SSD-63475709 Tumbi Umbi Retirement Living Project

Table 1. Response to Central Coast Council (5 February 2026)

Figure 1. 1% AEP flood level difference

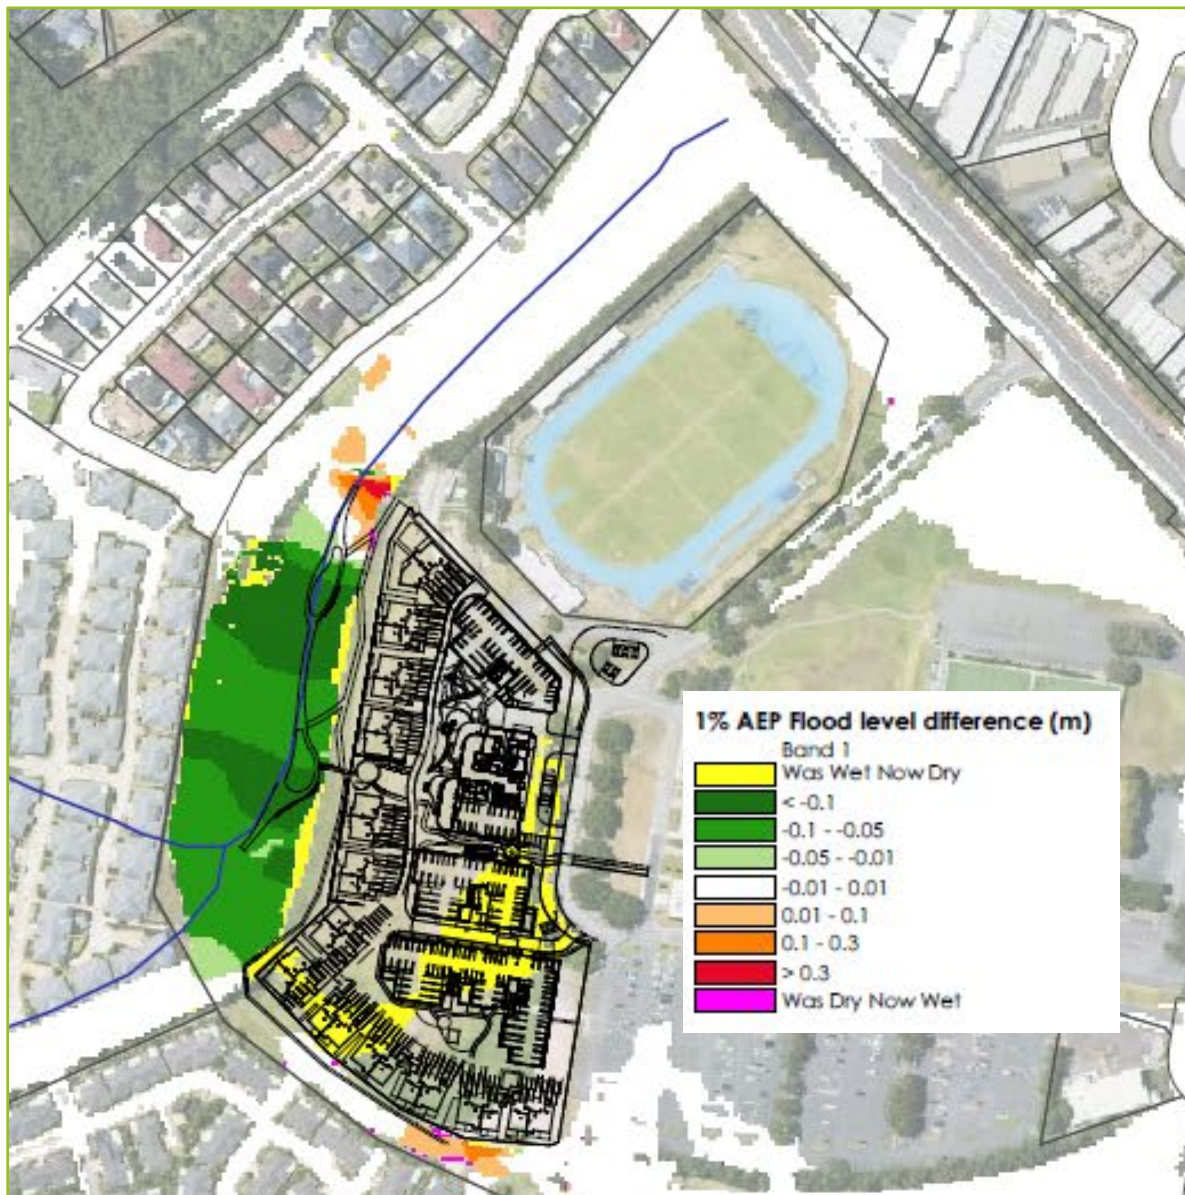
Submission	Response
	Table 5-1 also outlines ongoing maintenance requirements, which are to be undertaken in perpetuity (including weed control, planting management and fuel management).
Council would concur with the comments of DCCEEW, that the mitigation and management measures identified in the final BDAR and VMP be conditioned for implementation at the relevant stages of development. This is to include preparation of a Biodiversity section within the Construction Environmental Management Plan (CEMP).	Agreed, however implementation of the VMP should apply to the post-construction stage of the development, i.e., at a time that all construction phase activities (including channel restoration works) will not require any disturbance to the VMP area.
FLOODPLAIN DEVELOPMENT	
The Flood Impact Assessment shows an isolated increase in flood level in the existing watercourse presumably because that is where flow is being directed. The increase is shown to be greater than 300mm during the 1%AEP event. Floodplain Management acknowledge that this increase does not affect any neighbouring properties however cannot be sure that it is not going to have a detrimental impact on the existing natural habitats within the watercourse. Floodplain Management recommend that an ecologist provide comment about the significance (if any) of this impact. If there is not predicted to be any ecological impact resulting from this development Floodplain Management have no further issues.	The existing drainage channel adjacent to the site is concrete lined and the downstream wetland was constructed in the late 1990s. The constructed wetland was planted with macrophytes that are true aquatic species and capable of surviving various inundation levels. The 1% AEP flood level differences are shown in Figure 1 and the wetland shown in photo plates 1 & 2. Native vegetation growing on the batters of the existing channel also comprise terrestrial and semi-aquatic plant species (e.g., sedges, rushes, aquatic grasses and paperbarks); and that found in Forested Wetland vegetation formation and Coastal Forested Floodplain class. These wetland communities have evolved under periodic flooding conditions that would last longer than that of a post-development 1% AEP event. Temporary, infrequent increases in water levels of >300mm are considered highly unlikely to impact on wetland flora or fauna at this locality, or further downstream of the site.
